# Justification for Class III Permit Modification March 2005 SWMU 136 Operable Unit 1303 Building 907 Septic Systems at Technical Area II

NFA Originally Submitted August 1995

Comment Response October 1996

**Environmental Restoration Project  
Responses to NMED Technical Comments  
on No Further Action Proposals  
Dated June 1995**

Figure 2. Map Showing ER Site 136 Building 907 Septic System

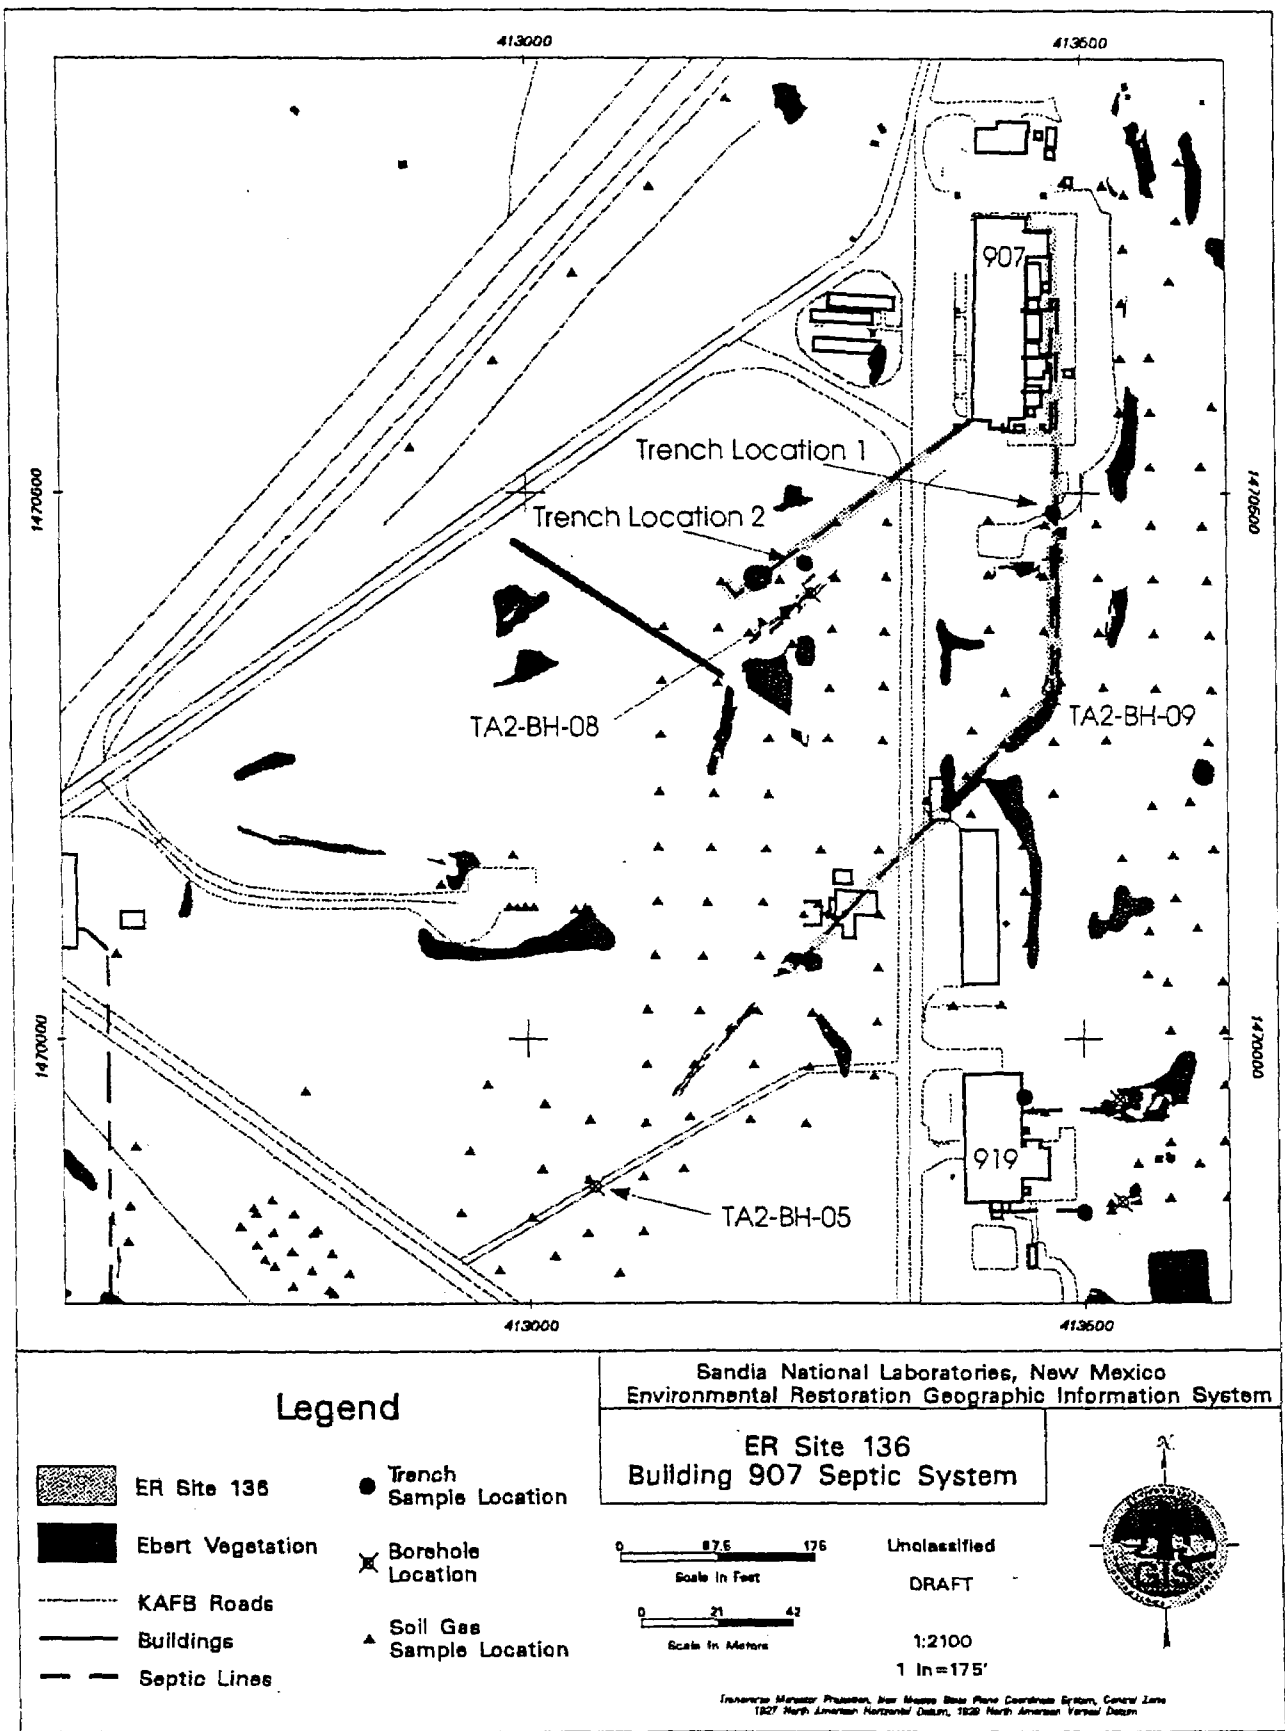
- i. **Page 6; Unit Characteristics: What did the drain line consist of and how deep was the line laid? Also, please provide a more detailed map of Figure 2. In addition, please provide a more detailed schematic or map of the sanitary system and HE drain system which clearly identifies all components of the system. Please describe the construction of the seepage pit.**
